SOLICITATION AMENDMENT
MODIFICATION DE L'INVITATION

Title - Sujet Elec., Communication & Elec. Safety	
Solicitation No. - N° de l'invitation 21C82-120400/A	Amendment No. - N° modif. 002
Client Reference No. - N° de référence du client 21C82-120400	Date 2013-07-25
GETS Reference No. - N° de référence de SEAG PW-\$PWY-020-7035	
File No. - N° de dossier PWY-3-36036 (020)	CCC No./N° CCC - FMS No./N° VME
Solicitation Closes - L'invitation prend fin at - à 02:00 PM on - le 2013-07-31	Time Zone Fuseau horaire Pacific Daylight Saving Time PDT
F.O.B. - F.A.B. Plant-Usine: <input type="checkbox"/> Destination: <input checked="" type="checkbox"/> Other-Autre: <input type="checkbox"/>	
Address Enquiries to: - Adresser toutes questions à: Ly, Ronny(PWY)	Buyer Id - Id de l'acheteur pwy020
Telephone No. - N° de téléphone (604) 666-0043 ()	FAX No. - N° de FAX (604) 775-6633
Destination - of Goods, Services, and Construction: Destination - des biens, services et construction: CSC - Fraser Valley Institution - Abbotsford, BC

This Amendment 002 (Addendum No. 2) is raised to provide clarifications to the specifications and drawings and to answer questions from bidders. Please note the Electrical Add

Proj. No. R.052462.001	Scale: 1:100	Date: 13 July 23	Designed: K.B.	Drawing No.: ESK-E400-01
---------------------------	-----------------	---------------------	-------------------	-----------------------------

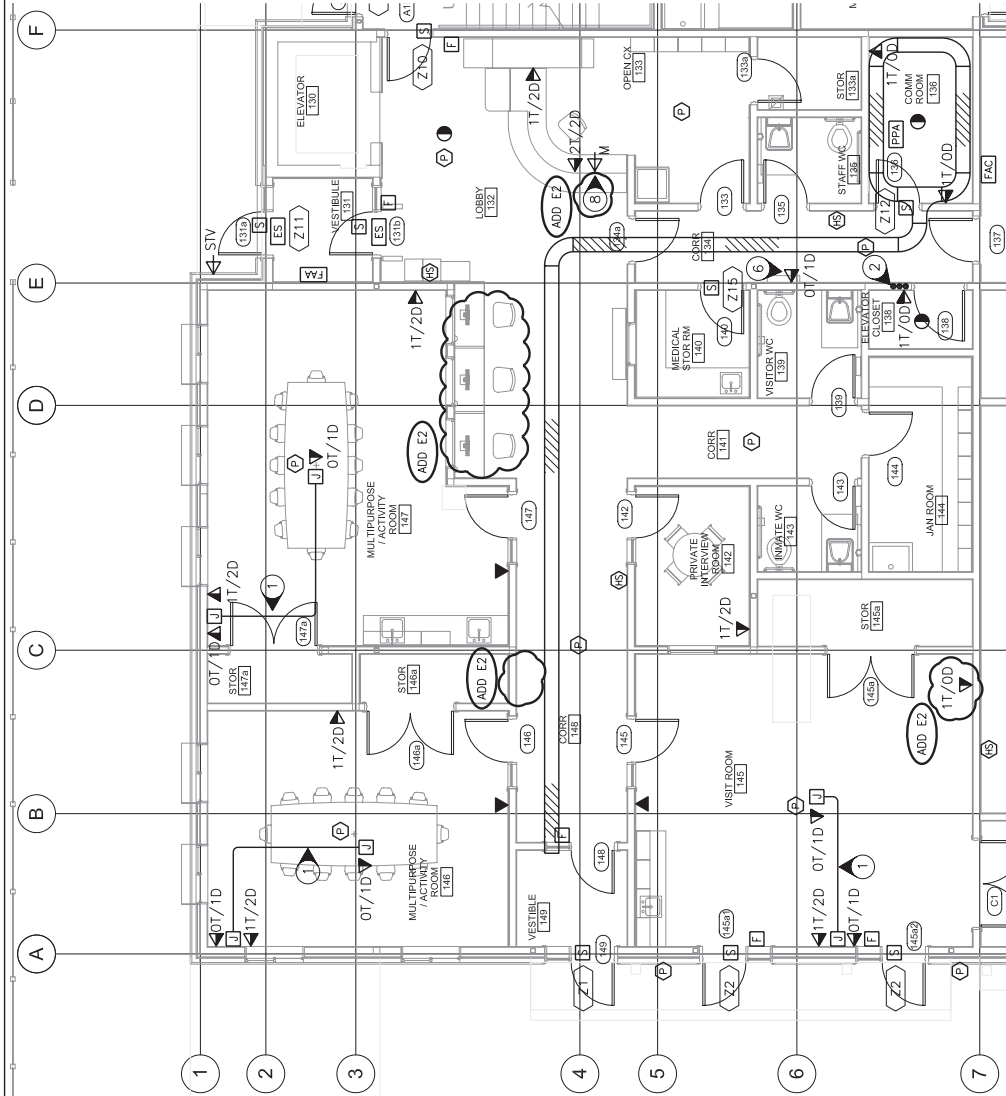
- .1 **Delete:** Inmate telephone in Corridor 148. See ESK-E400-01.
- .2 **Delete:** Computer workstation structured cabling outlets in Corridor 148. See ESK-E400-01.
- .3 **Revise:** Refer to ESK-E400-01 for the revised structured cabling drop count in Visit Room 145.

- .4 **Add:** Coordinate mounting and location of intercom station with the Departmental Representative. See ESK-E400-01.
